AIA
Austin

CodeNEXT Charrette Report

Published by the Austin Chapter of the American Institute of Architects
July 31, 2017

Figure 1.4: Existing Non Compliance

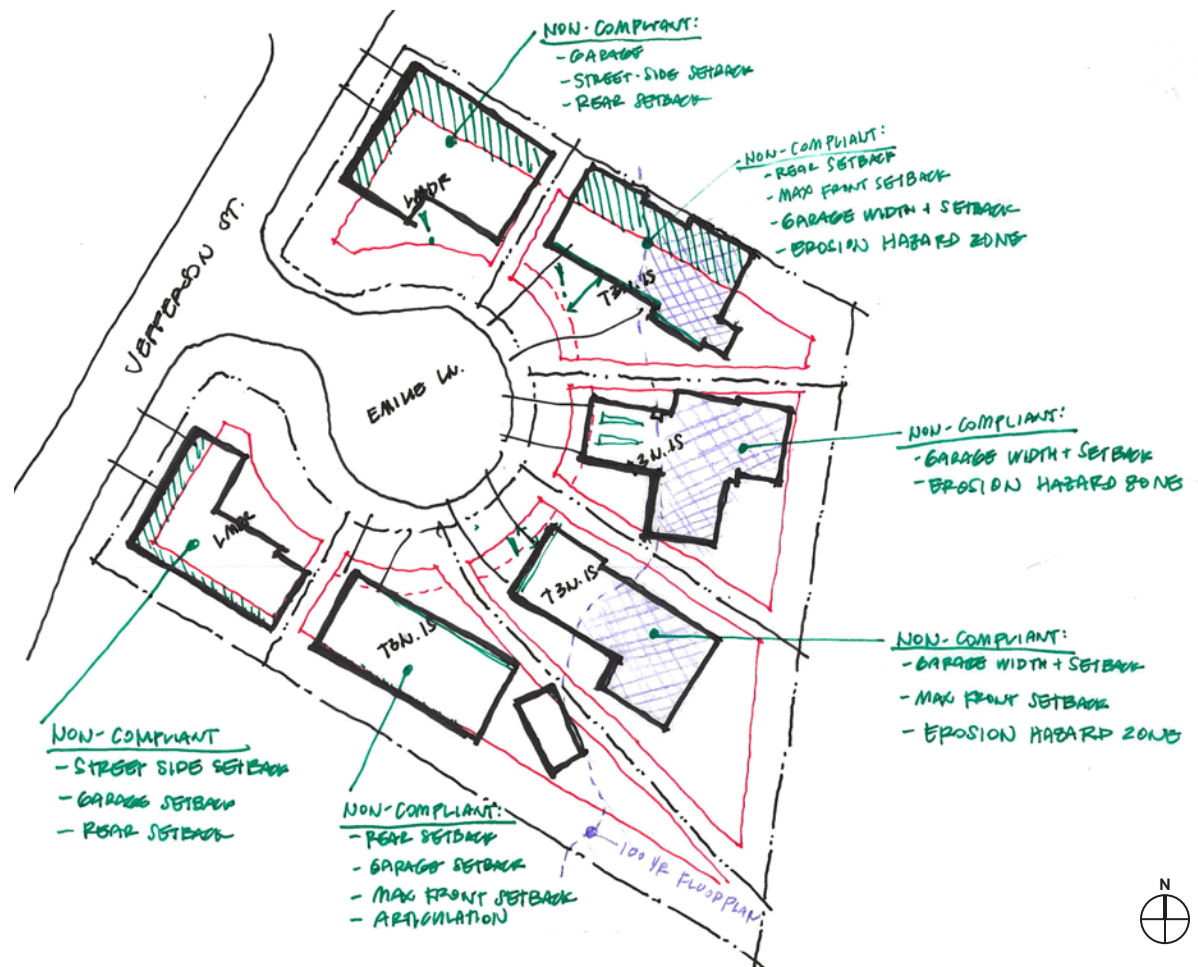
The rigidity of the form-based regulations preclude designers' ability to design sensibly around a site's context, favoring an "use it or lose it" approach that prioritizes control over the built form. Any buildable area lost due to a heritage tree, for example, would not be credited back to a project somewhere else on the site outside of the predetermined envelopes. The prescribed footprint shape prevents a single-story home larger than 1,688sf on a standard 50ft lot, which could be undesirable for an aging population. Additional envelope restrictions included an allowable height of two stories for primary buildings in lieu of the three that many current projects are achieving with an occupied attic, and a combined minimum side setback of 15ft that effectively precludes development of any existing 25ft wide lots. The team determined that regulating building heights as a measurement to the eave or parapet will favor traditional gabled or hipped roofs as a byproduct, due to the bonus height gained under the roof pitch. Architecture that attempts to use parapets will, when compared to a similar project with a traditional roof line, be disproportionately impacted. Minimum and maximum front and side setbacks place buildings, on average, ten feet closer to the street, but the narrow 10ft zone established for the primary building facade will likely need variances to work around obstructions, such as mature, protected trees which have been the result of decades of 25ft front setbacks.

Overall prescriptiveness of the draft code can be highlighted by the six existing lots on Emilie Ln., the cul-de-sac with oddly-shaped parcels. All six homes would be non-compliant to varying degrees under the proposed regulations, mostly due to garage widths and setback violations. (Figure 1.4) Non-compliance is certain to be found on standard lots as well, which could, unless a modest increase in non-compliance is allowed for remodels and additions, encourage demolition of older housing stock. The proposed code does not provide enough flexibility to work for these non-standard lot shapes without requiring a variance or discretionary approval.

Figure 2.3: Block Studies

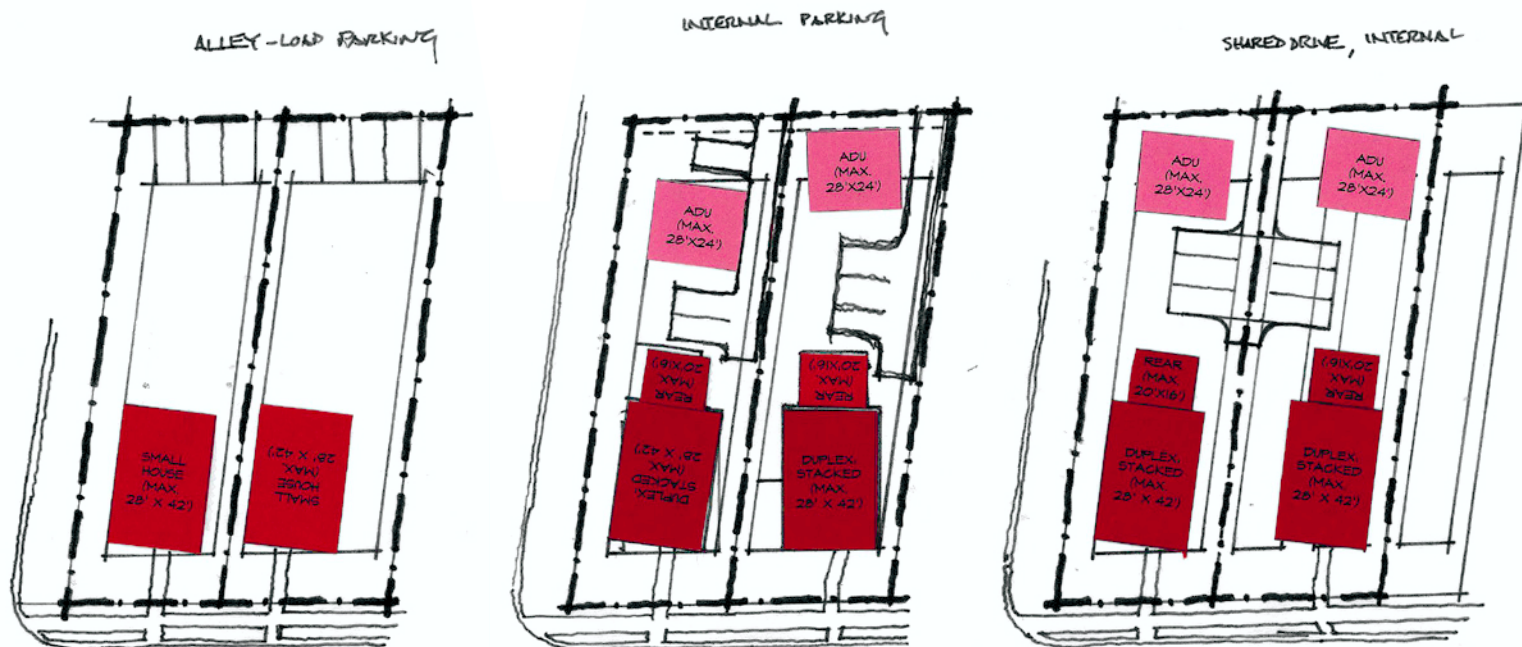
Successes on this Test Area occurred most often when there was an improved alley, which was conducive to efficient parking access and thus free-up impervious cover for more productive uses. The success was also owed, in part, to the relatively generous lot sizes. It is reasonable to assume that smaller lot sizes, approaching the minimum requirements may not have seen as much success. By contrast, the T3MS building types, especially Live/Work, were most efficient when the properties were approaching the minimum lot size requirements.

Figure 3.4A : Cottage Court Building Type - 8th Street

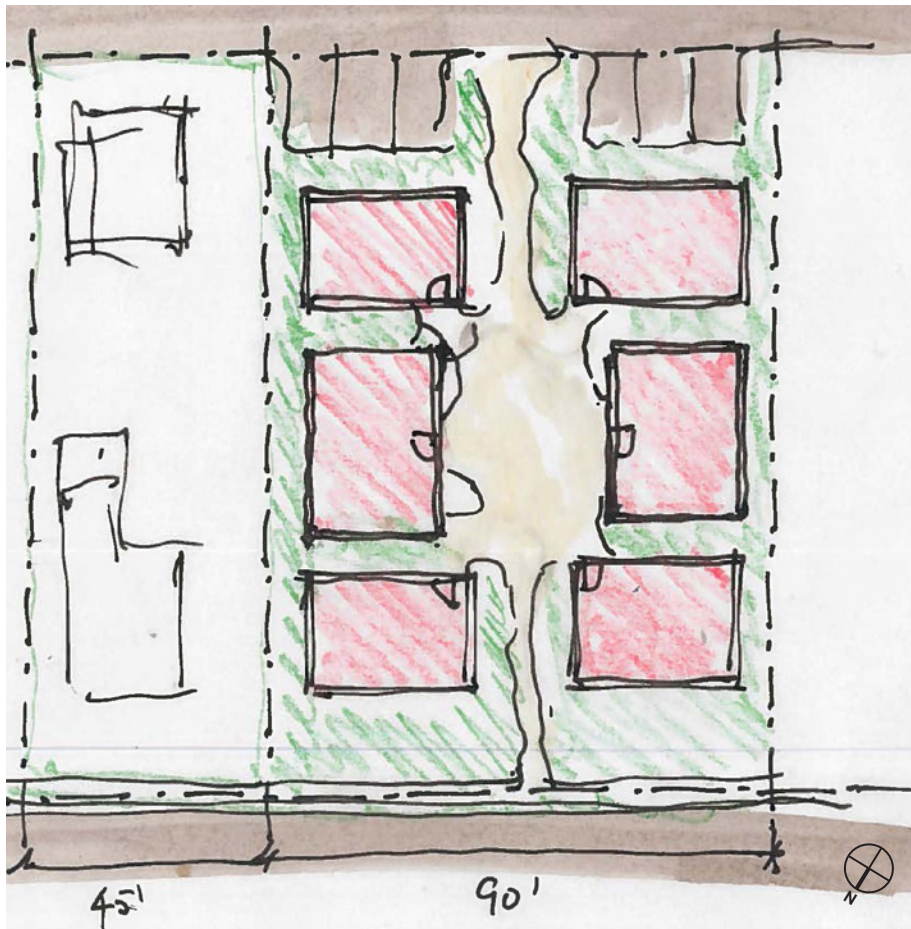
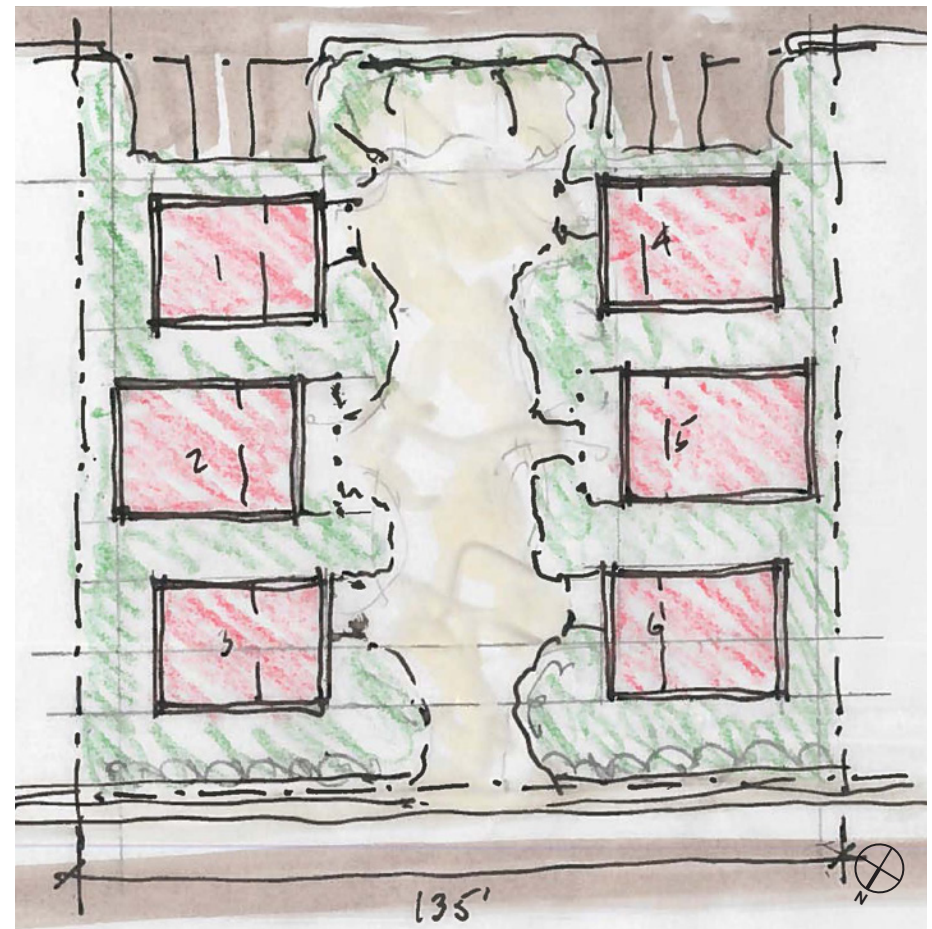
Since the existing lots are only 45-feet wide, for the Cottage Court scheme the team needed to consolidate lots. *Figure 3.4A* shows how they could get six 1,200 SF units on two combined lots, plus another three units on the adjacent 45-foot lot, totaling nine units.

This is compared to only six units total on the scheme which aggregated all three lots into one (*Figure 3.4B*). The conclusion is that the Cottage Court development standards make this form non-competitive, compared to other permitted building types, because of the

Figure 3.6: Medium Multiplex + ADU Scheme on 8th Street

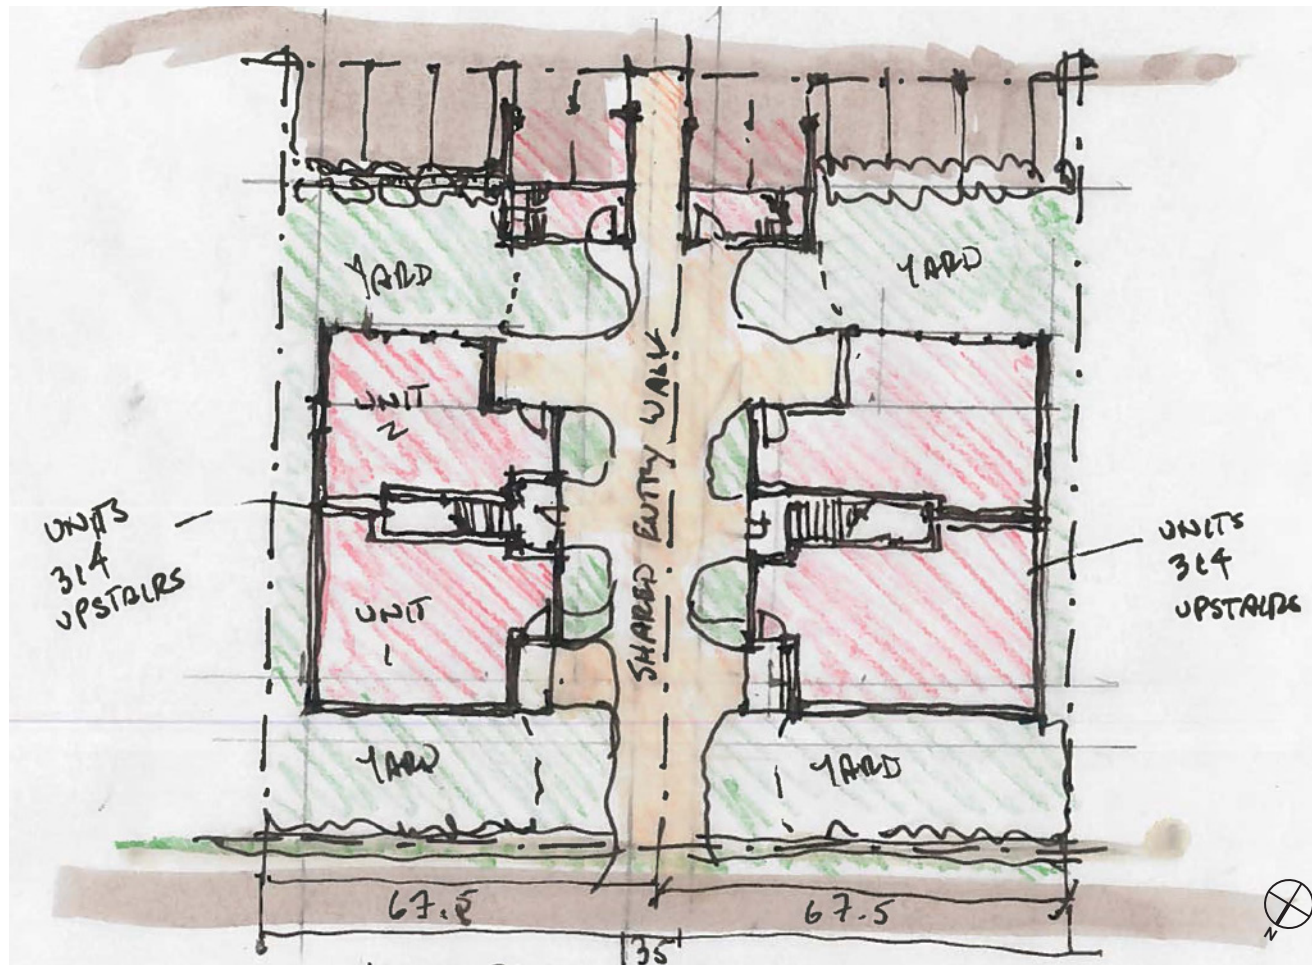
Using the Medium Multiplex building type with an ADU, the team could produce ten units on three lots replatted as two (Figure 3.6). This scheme produced the most density, but the improvements on these lots require replatting lots to maximize the entitlements and once again, the alley was essential in the solution. This means the proposed code does not create the best tools for achieving this density. The added step of aggregating or replatting should not be necessary to meet these goals.

Figure 3.8: Webberville Road & Swenson Street Redevelopment

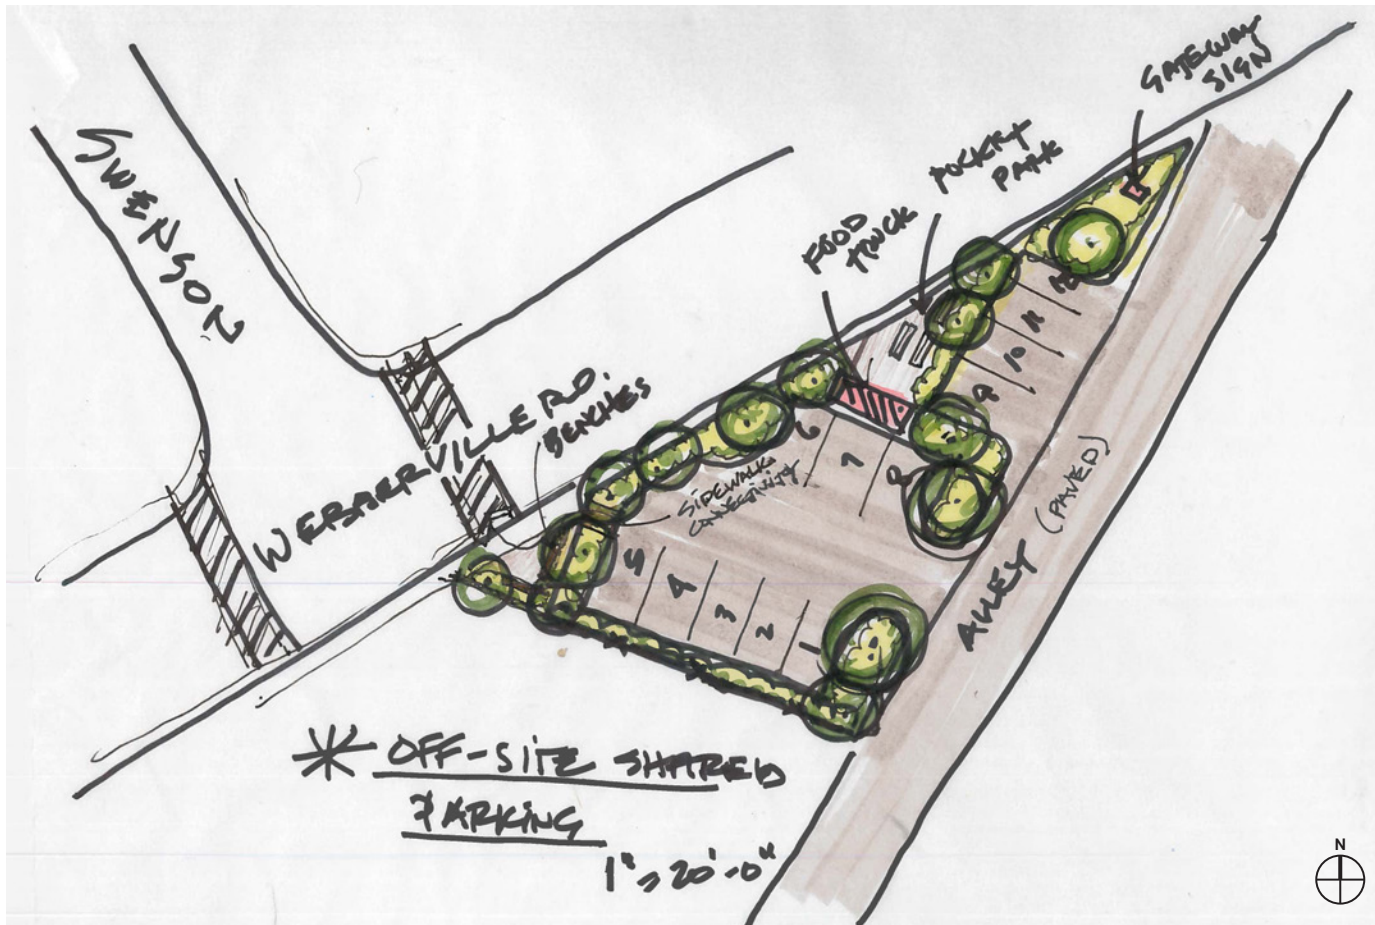
Given the triangular shape of the lot, and the form constraints of the draft code, it was determined the lot at the end of Swenson could best serve this district as a shared off-site parking area and/or pocket park (Figure 3.8). It simply is not a developable piece of land under the draft code's prescriptive width & depth requirements.

Figure 4.3: Test Sites 4B&4C Redevelopment Plan

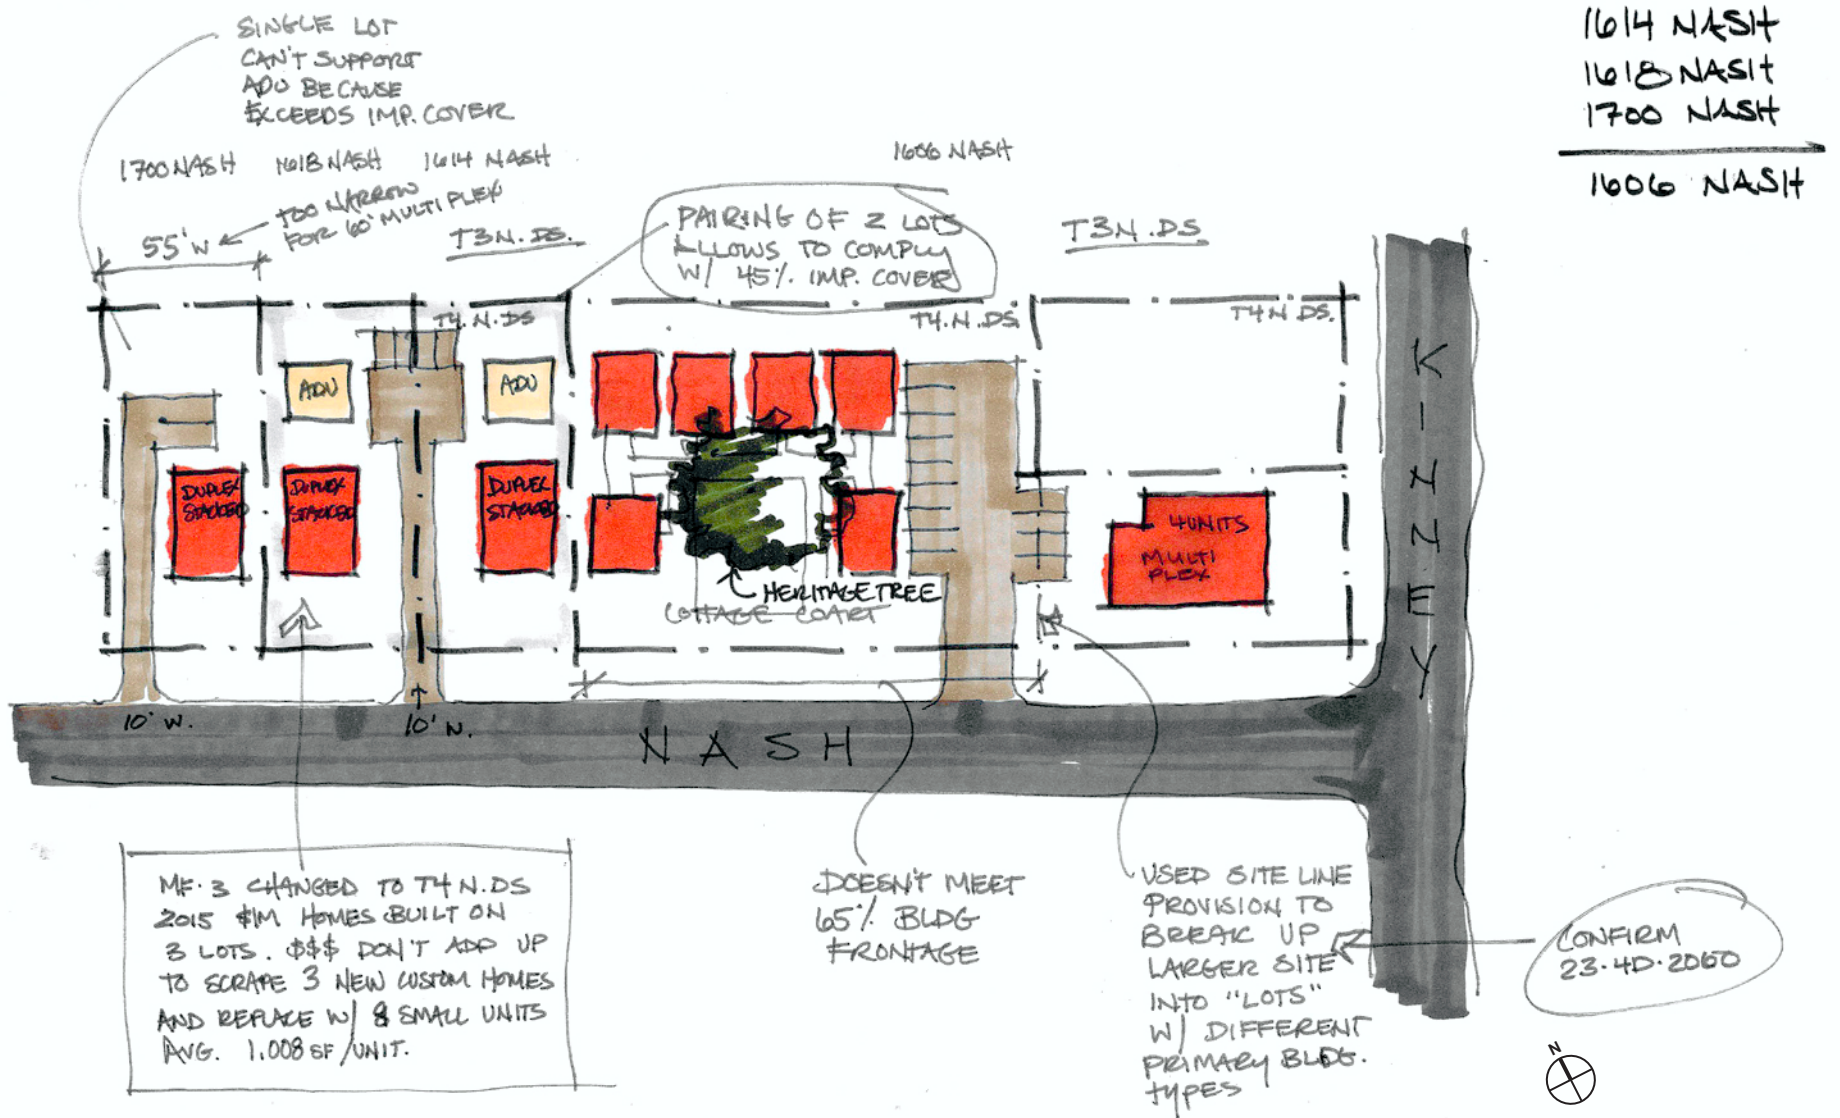
One parcel could only be redeveloped with one stacked duplex because of impervious cover limits. The two remaining parcels, if redeveloped at the same time, could share a driveway and provide two small ADUs above parking (see Figure 4.3). The team assumed the garage could go under the ADU so ADU size is limited in living area to 672 sf. This scheme fit a total of eight dwelling units totaling 8,064 square feet total (1,008 sf avg. per unit) on the three lots producing a potential FAR of 0.40. This is not much more living area than is currently contained in the existing single-family homes. The ADUs had to be much smaller than currently allowed by code.

Under certain lot configurations, the proposed zoning will produce less unit counts, but larger units, than what is existing today. Further, the test sites only worked when driveway and parking was shared. The other lot doesn't work for an ADU because it can't fit a driveway in and still meet the impervious cover limit of 45% (23-4D-3090). The T4 zoning appears to provide the same development entitlements for these lots. T3 and T4 does not necessarily increase density, which does not meet imagine Austin goals.
